MAD-42-12.35

MODEL: Sheet PAPERSET: 17x11 (in.) DATE: 5/19/2026 TIME: 11:24:58 AM PLTDRY: OHDOT_PDF.plt USER: Tshoemaker@ircsdutlins.com WORKSPACE: OHDOTC:\e02 WORKSET: 109072_PRODUCT: OpenRoadsDesigner_24.00.02.25 pwc:\trc-pw.bentley.com\trc-pw-01\Documents\5 - Projects - External\Ohio Department of Transportation (ODOT)\3232009 - MAD42-12.35\4 - Design & Study Documents\405 - Drawings\109072400-Engineering\Roadway\Sheets\109072_GN002.dgn

NEW SHEET

ERROR CORRECTED

ITEM SPECIAL - MAILBOX SUPPORT

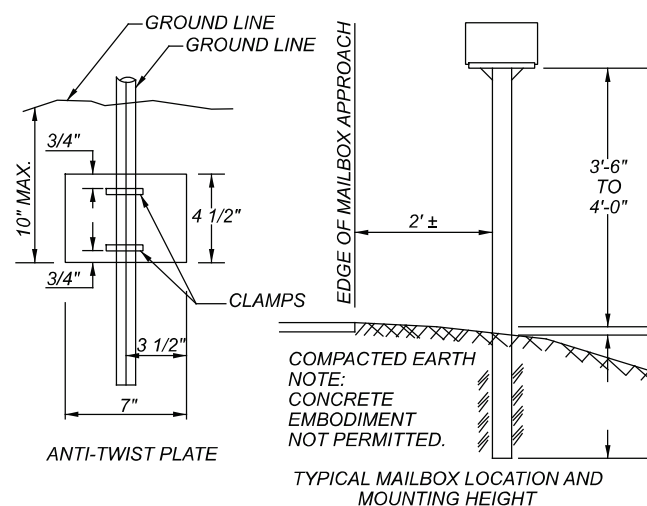
THE FOLLOWING QUANTITY HAS BEEN INCLUDED IN THE GENERAL SUMMARY:

ITEM SPECIAL	MAILBOX SUPPORT SYSTEM, SINGLE	4 EACH
--------------	--------------------------------	--------

PLAN AND PROFILE - U.S. 42
 STA. 60+60 TO STA. 65+60

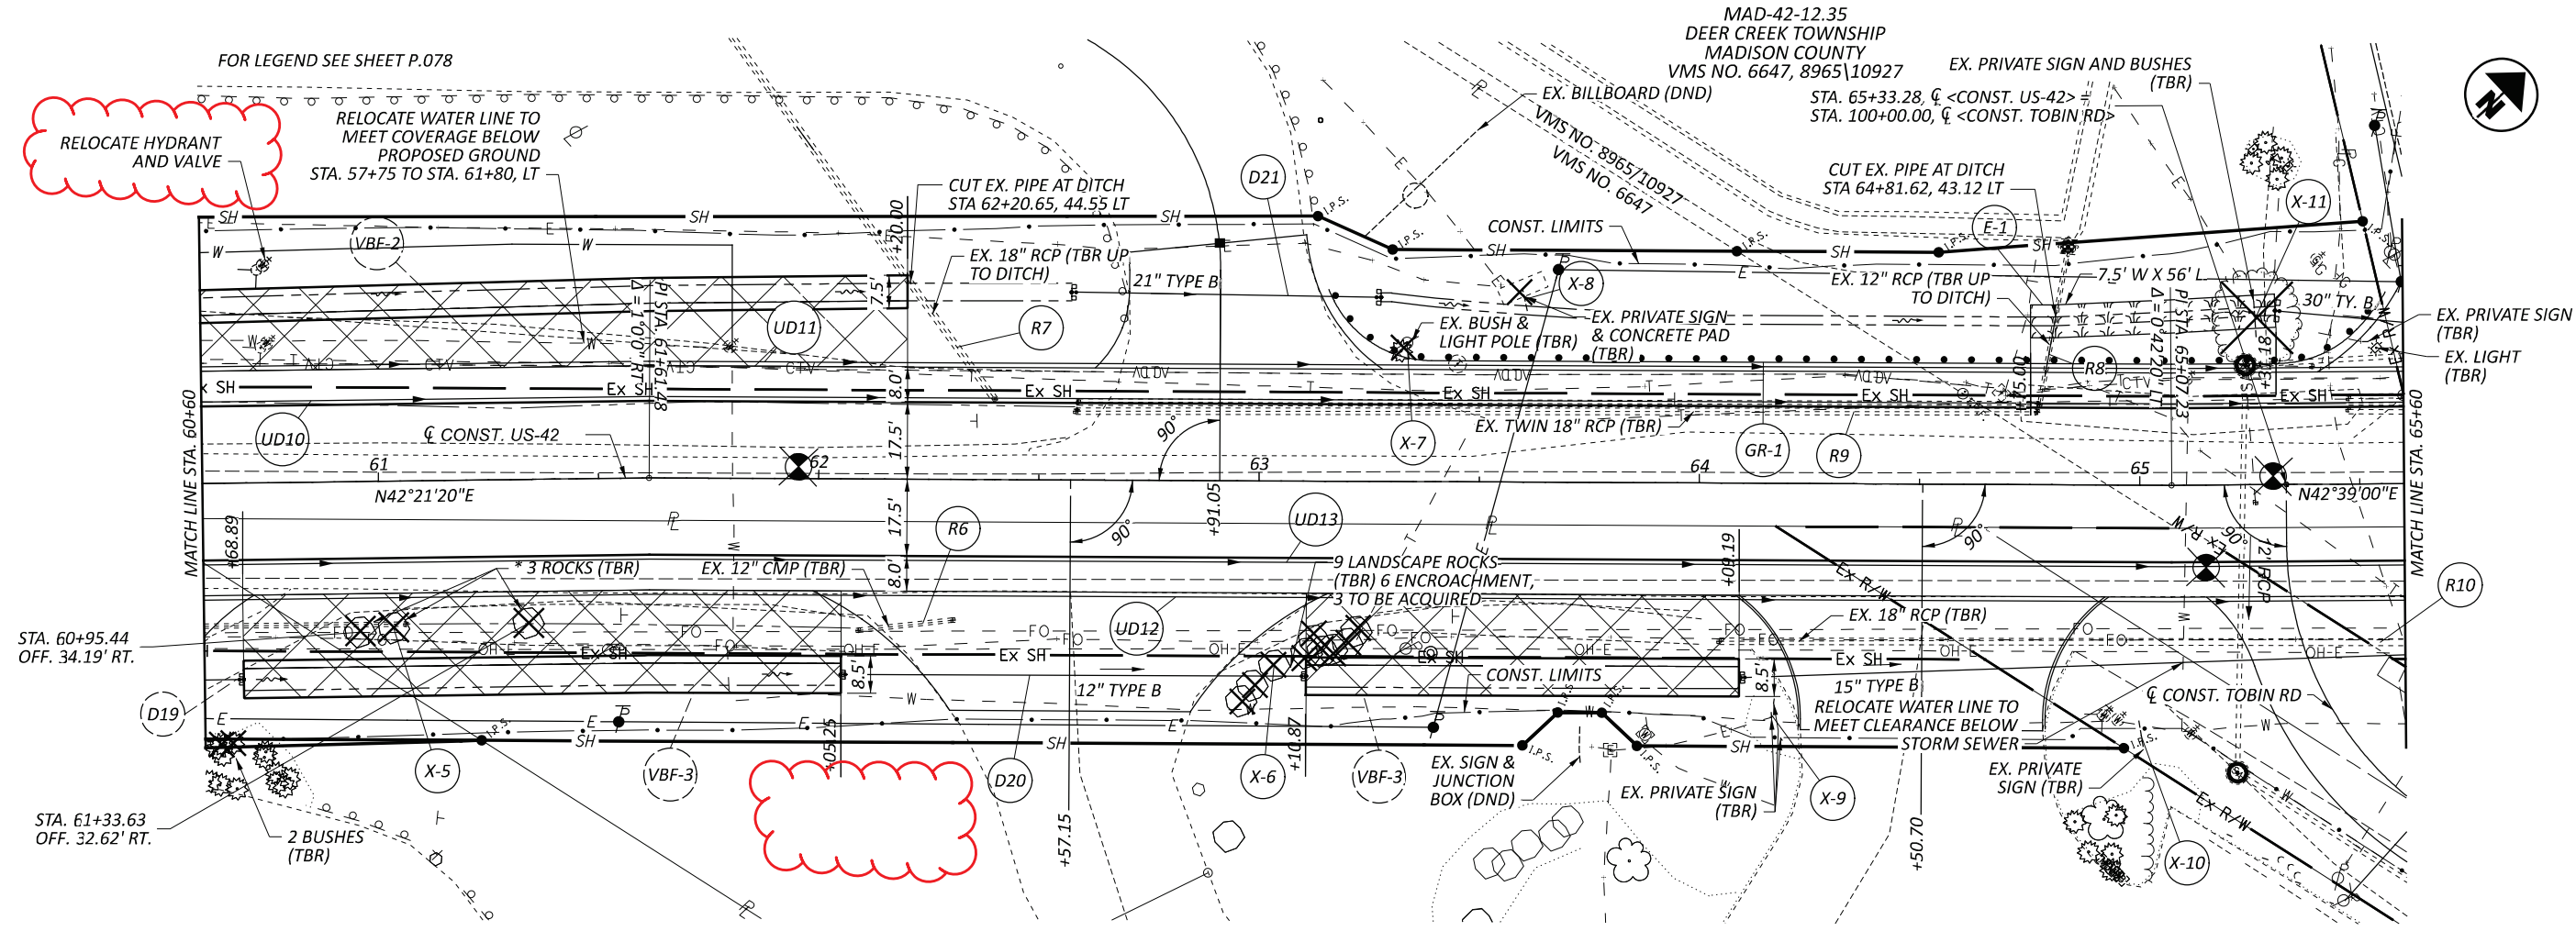
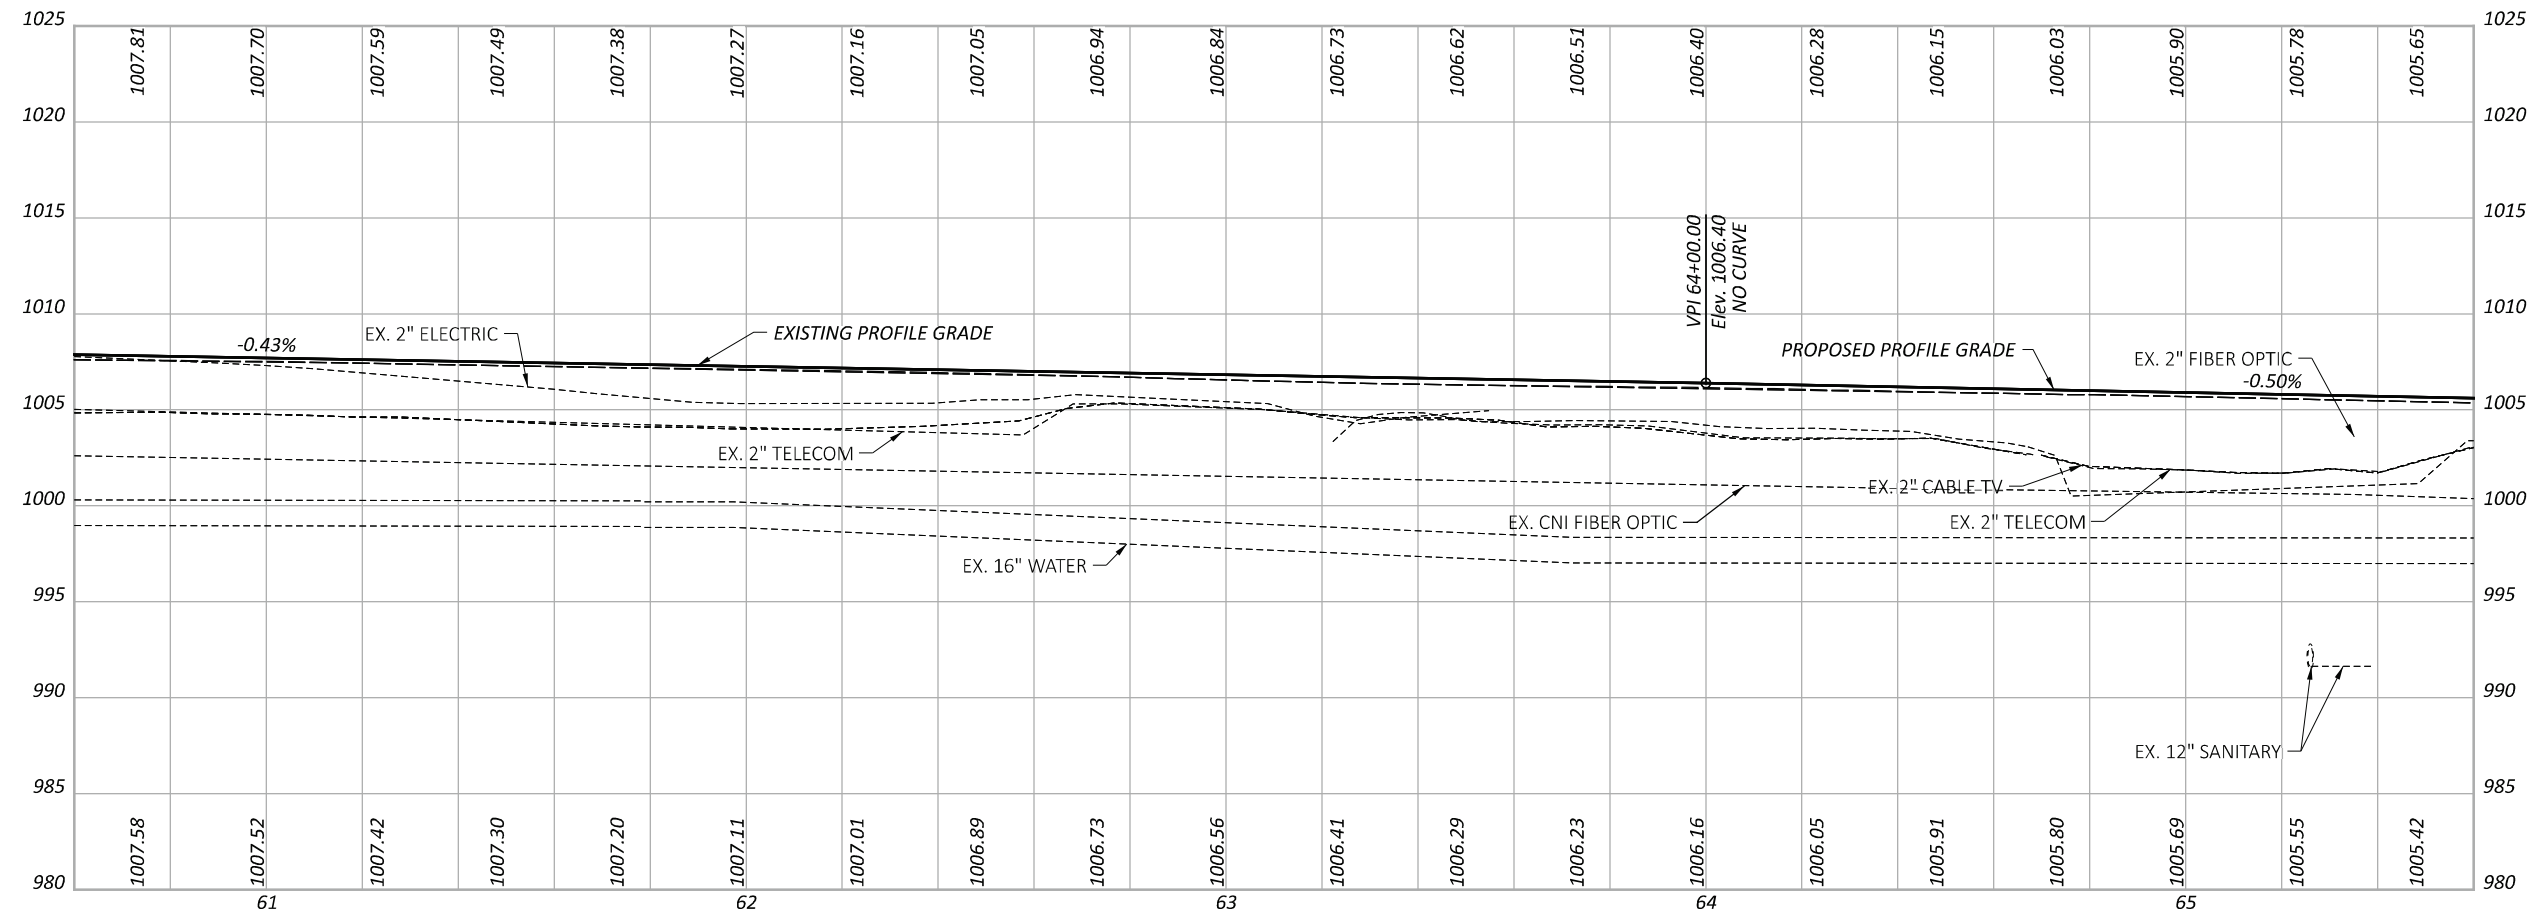
RELOCATE HYDRANT AND VALVE

RELOCATE WATER LINE TO MEET COVERAGE BELOW PROPOSED GROUND STA. 57+75 TO STA. 61+80, LT

RELOCATE WATER LINE TO MEET CLEARANCE BELOW STORM SEWER
